Beechcraft SERVICE INSTRUCTIONS

No. 1245
ATA Code 53-10
Recurring Inspection

SUBJECT: FUSELAGE - INSPECTION FOR CORROSION AT THE FIREWALL AND F.S. 68.00 FRAME.

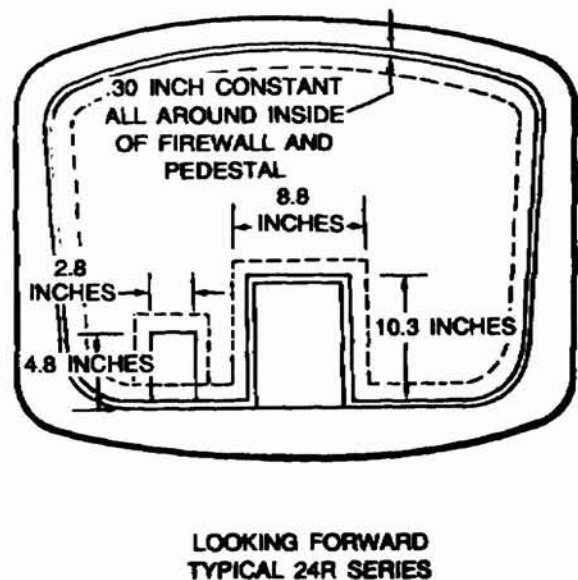
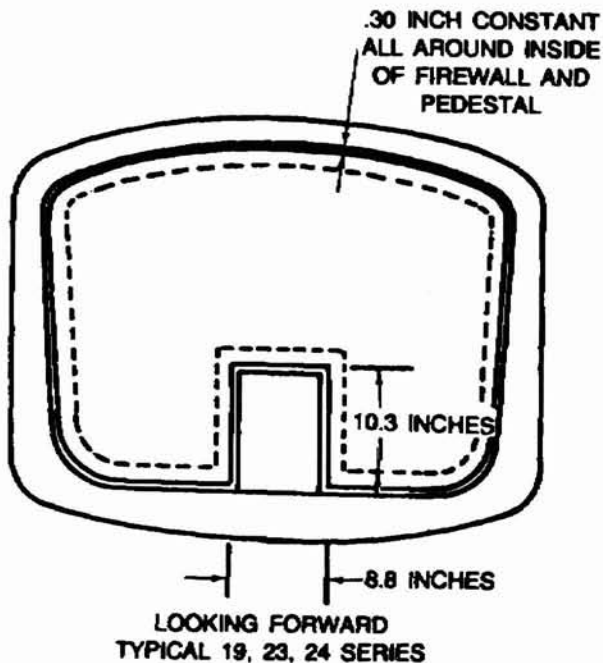
1. Refer to the Shop Manual and remove the front seats and glareshield.
2. Inspect the F.S. 68.00 (firewall) frame for corrosion, paying particular attention to any areas where the upholstery fabric on the aft side of the firewall comes in

contact with the aluminum frame (see illustration).

1. The first time the firewall is removed for any reason, trim the firewall fabric and insulation/soundproofing material so that the fabric clears the forward face of the console and the F.S. 68.00 frame by approximately .3 inch around the entire edge of the fabric.
